[Docket No. 94-NM-28-AD; Amendment 39-9528; AD 95-13-12 R1]

Airworthiness Directives; Boeing Model 767 Series Airplanes Equipped With General Electric CF6-80C2 Series Engines

ACTION: Final rule; correction.

**Electro-Mechanical Brake and CDU Cone Brake Torque Check
Figure 1**

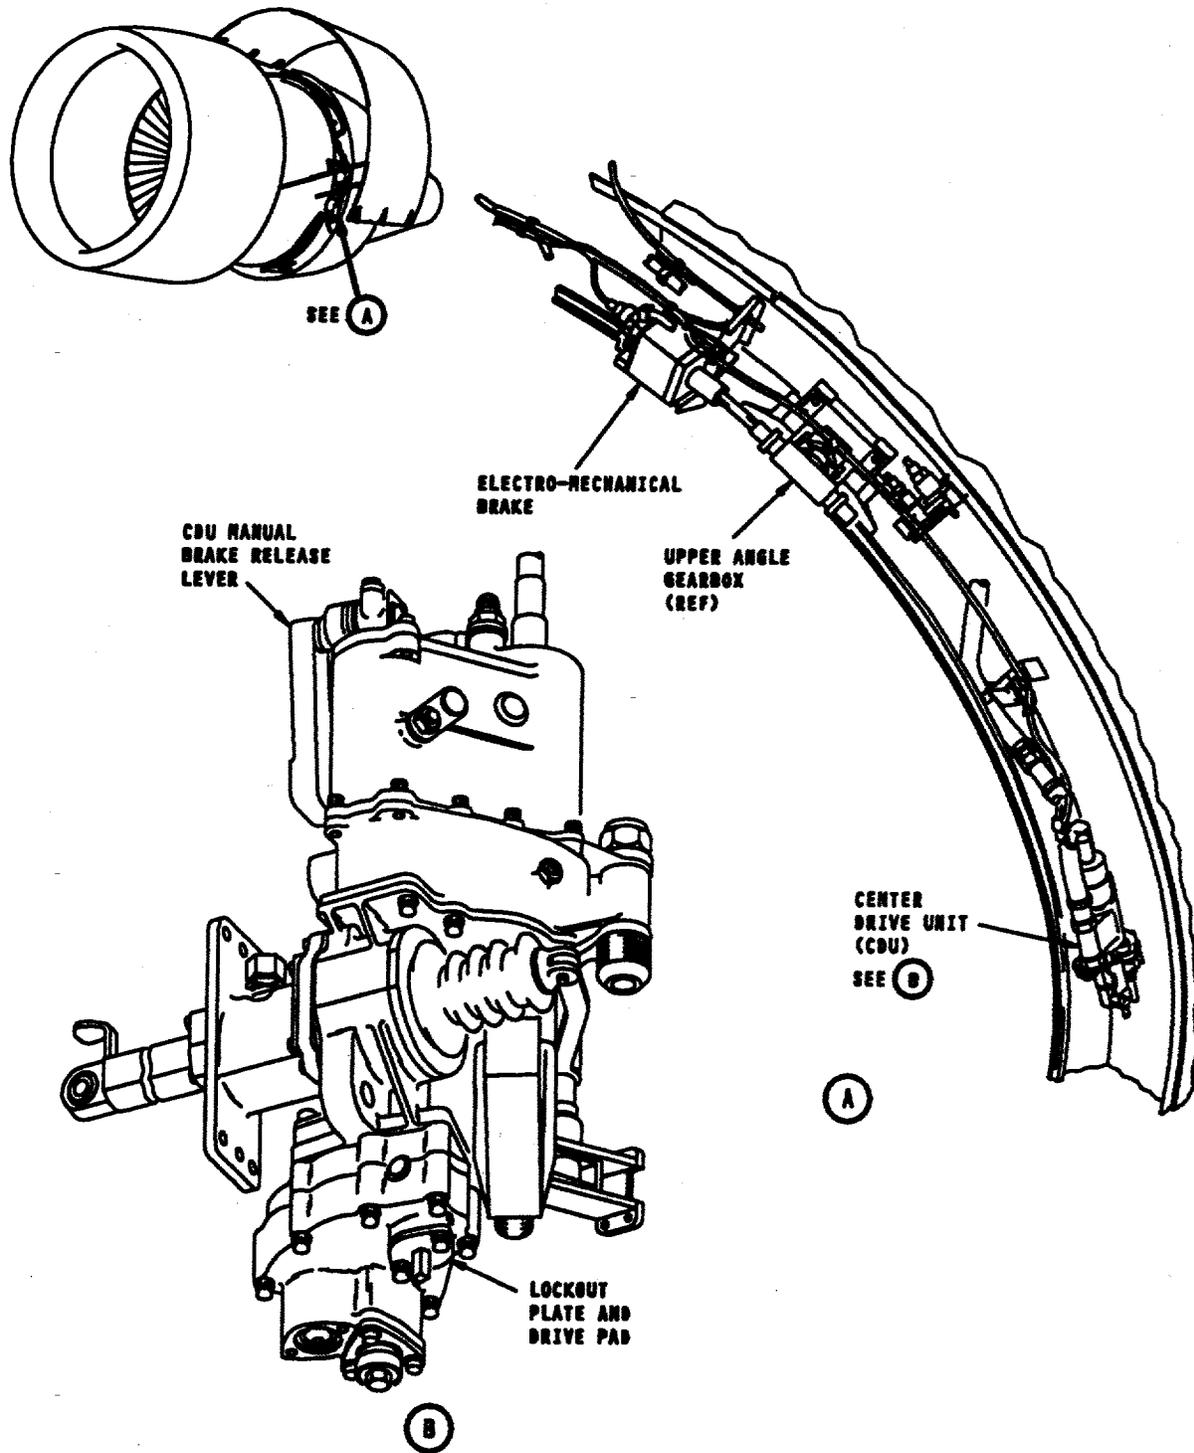
Since the issuance of that AD, the manufacturer has advised the FAA that a torque check value specified in Appendix 1 of the AD requires clarification. The procedures originally provided to the FAA for accomplishment of a torque check of the cone brake of the center drive unit (CDU) indicate that operators should not use more than 130 pound-inches of torque when performing the check. While using 130 pound-inches of torque would not damage the CDU, the manufacturer has advised the FAA that 100 pound-inches of torque is the appropriate value. Accomplishing the torque check up to 100 pound-inches is intended to identify a CDU having a decaying torque level due to a soft shaft problem, while at the same time not exposing the brake to unnecessarily high torque/stress levels.

2. Electro-Mechanical Brake and CDU Cone Brake Torque Check (Fig. 1)

Note: You will need a 24-inch extension to provide adequate clearance for the torque wrench.
 - (e) Apply 90 pound-inches of torque to the system.
 - (1) The electro-mechanical brake system is working correctly if the torque is reached before you turn the wrench 450 degrees (1 1/4 turns).

- (2) If the flexshaft turns more than 450 degrees before you reach the specified torque, you must replace the long flexshaft between the CDU and the upper angle gearbox.
- (3) If you do not get 90 pound-inches of torque, you must replace the electro-mechanical brake.
- (f) Release the torque by turning the wrench in the opposite direction until you read zero pound-inches.
 - (1) If the wrench does not return to within 30 degrees of initial starting point, you must replace the long flexshaft between the CDU and upper angle gearbox.
 - (3) Fully retract the thrust reverser.
- C. Do a check of the torque of the CDU cone brake:
 - (1) Pull up on the manual release handle to unlock the electro-mechanical brake.
 - (2) Pull the manual brake release lever on the CDU to release the cone brake.

Caution: Do not use more than 100 pound-inches of torque when you do this check. Excessive torque will damage the CDU.

(6) Turn the torque wrench to try to manually extend the translating cowl until you get at least 15 pound-inches.

(a) If the torque is less than 15 pound-inches, you must replace the CDU.
